**Brunswick Harbor Navigation Project Modifications  
and Harbor Dredging Operations and Maintenance  
Glynn County, Georgia**

**Integrated Feasibility Report and Environmental  
Assessment**

**Appendix K: Fish and Wildlife Coordination Act  
Evaluation and Endangered Species Act  
Coordination**

**November 2021**

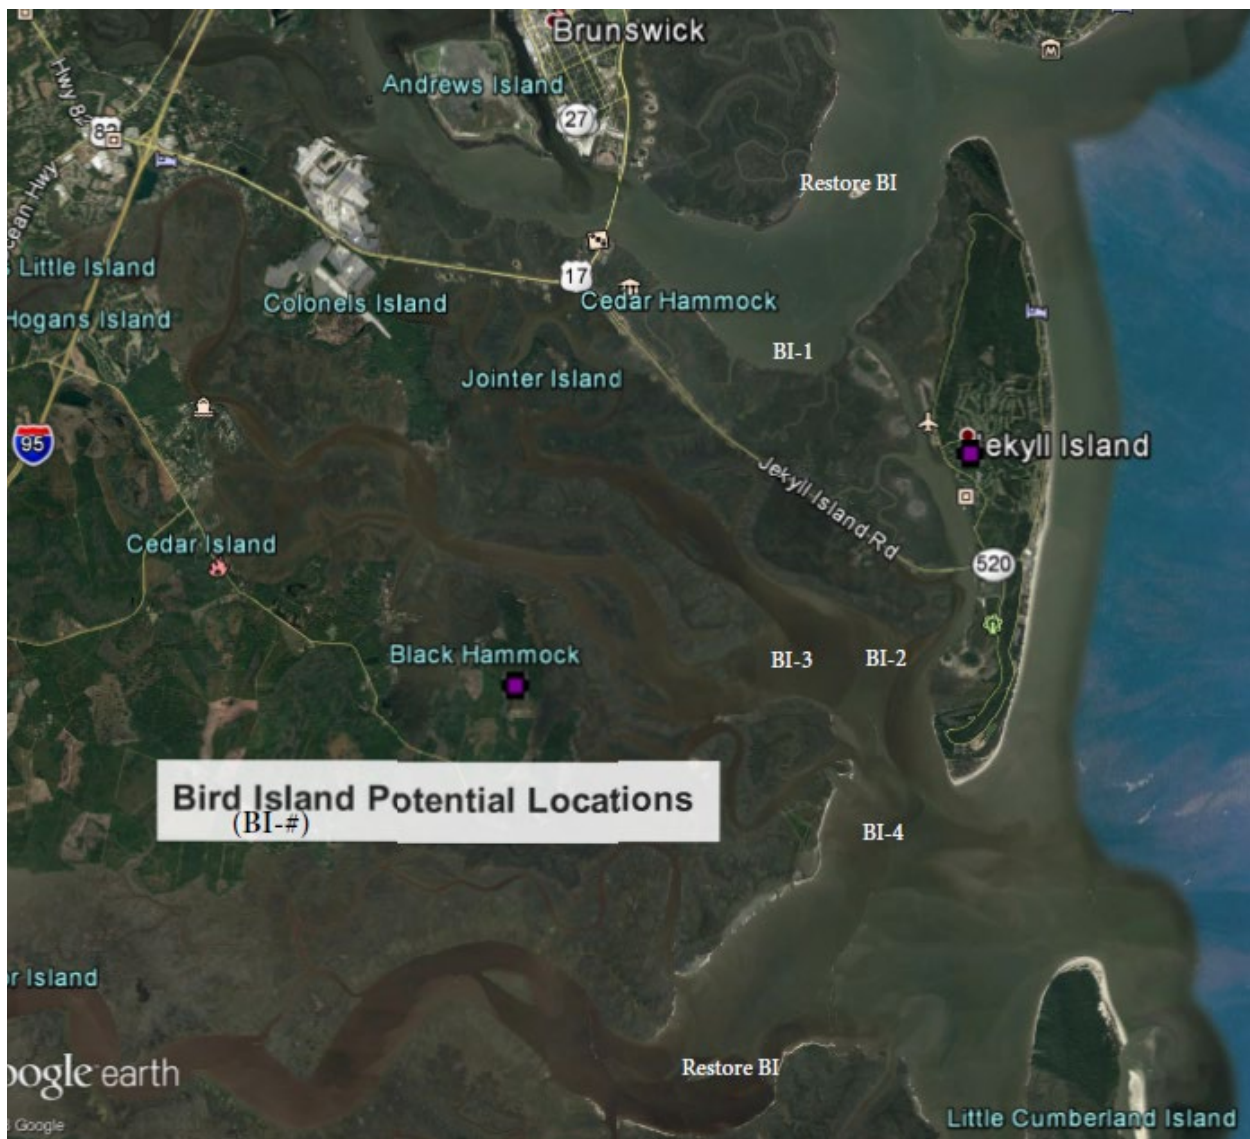
Create a new bird island or islands in shallow somewhat protected areas of St. Simons, Jekyll, and/or St. Andrews Sounds. As general conditions, we recommend not armoring any new islands, thereby making them subject to natural forces and making them temporary impacts to the shallow subtidal non-vegetated flats or unconsolidated soft sediment bottom in the estuaries that currently serve as EFH. This will also serve to keep the channel widening dredge sediments in the sediment system as opposed to placement in a DMCA.

Instead of simple round or oblong islands with increasing elevation toward the middle, we recommend that features such as tidal pools, varying elevations to create large intertidal areas, and/or planting of saltmarsh cordgrass (*Spartina alterniflora*) be incorporated into any design. We recommend a minimum size of 5 acres of dry bird nesting habitat, but larger is better.

Bird islands should be located with open water between the proposed island and exposed mudflat or marsh at low tide to discourage predators such as raccoons from accessing the islands during nesting. The existing bird island in St. Simons sound has 0.5 mile of open water between it and the mud flat nearby the marsh edge. It has experienced little or no mammalian predation. A minimum distance to achieve only slight mammalian predation cannot be recommended as factors such as water current velocity and area predator density are not known or are variable.

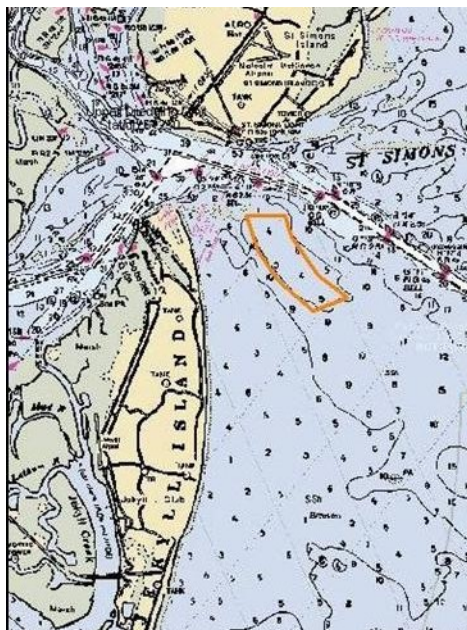
Bird island potential location 2 (BI-2) – Create a bird island near Jekyll Creek at Jekyll Sound across the inter-coastal waterway (ICW) from Jekyll Island. This would be a location protected from severe storms by Jekyll Island to the east. It's location near the ICW may cause it to be an attractive place for human recreation. This may result in disturbance to shore and seabird nesting. Conversely it would be convenient for monitoring by passing law enforcement patrols. The location is 2.5 miles from Jekyll Island Airport. It may be considered to be within the approach/departure area depending on how wide an angle the FAA uses from a straight approach to the runway.

Bird island potential location 3 (BI-3) – Create a bird island in Jekyll Sound near Joiner Creek. This location would be further away from most boating traffic and somewhat protected from severe storms by Jekyll Sound. It is 3.0 miles from Jekyll Island Airport. It is a wider angle away from the runway and may be considered to be outside the approach/departure area depending on how wide an angle the FAA uses from a straight approach to the runway.

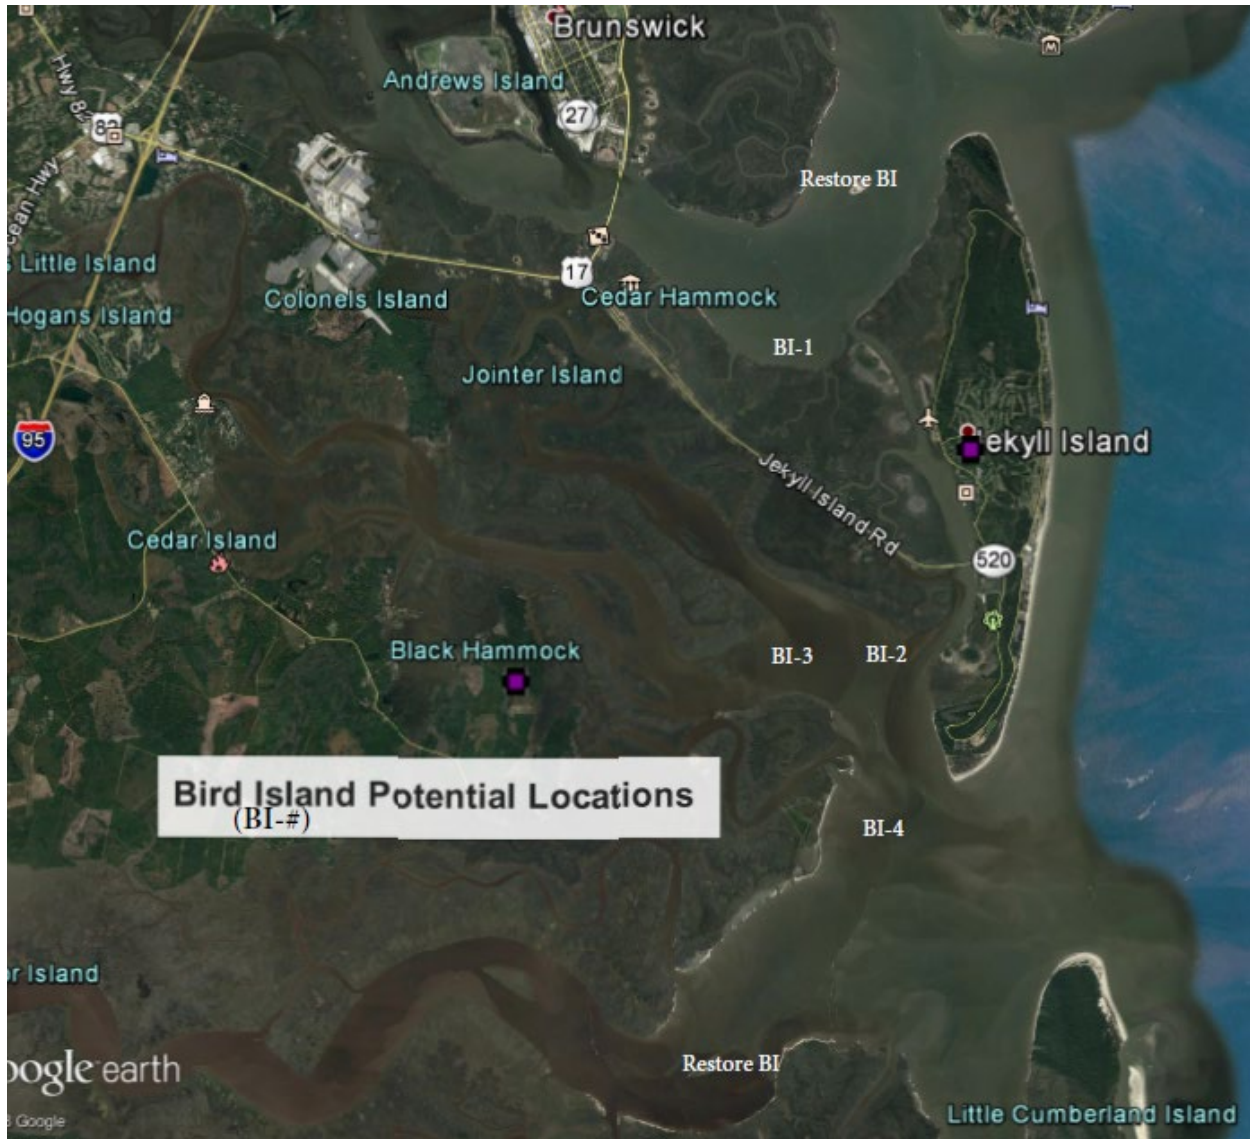
Create a new bird island or islands in shallow somewhat protected areas of St. Simons, Jekyll, and/or St. Andrews Sounds. As general conditions, we recommend not armoring any new islands, thereby making them subject to natural forces and making them temporary impacts to the shallow subtidal non-vegetated flats or unconsolidated soft sediment bottom in the estuaries that currently serve as EFH. This will also serve to keep the channel widening dredge sediments in the sediment system as opposed to placement in a DMCA.

Instead of simple round or oblong islands with increasing elevation toward the middle, we recommend that features such as tidal pools, varying elevations to create large intertidal areas, and/or planting of saltmarsh cordgrass (*Spartina alterniflora*) be incorporated into any design. We recommend a minimum size of 5 acres of dry bird nesting habitat, but larger is better.

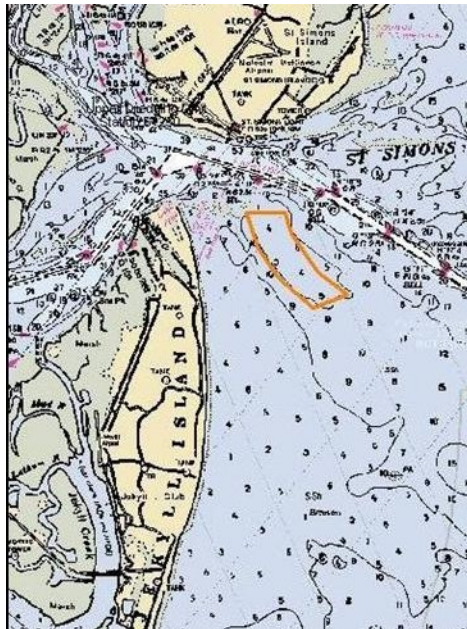
Bird island potential location 2 (BI-2) – Create a bird island near Jekyll Creek at Jekyll Sound across the inter-coastal waterway (ICW) from Jekyll Island. This would be a location protected from severe storms by Jekyll Island to the east. It's location near the ICW may cause it to be an attractive place for human recreation. This may result in disturbance to shore and seabird nesting. Conversely it would be convenient for monitoring by passing law enforcement patrols. The location is 2.5 miles from Jekyll Island Airport. It may be considered to be within the approach/departure area depending on how wide an angle the FAA uses from a straight approach to the runway.

Bird island potential location 3 (BI-3) – Create a bird island in Jekyll Sound near Joiner Creek. This location would be further away from most boating traffic and somewhat protected from severe storms by Jekyll Sound. It is 3.0 miles from Jekyll Island Airport. It is a wider angle away from the runway and may be considered to be outside the approach/departure area depending on how wide an angle the FAA uses from a straight approach to the runway.
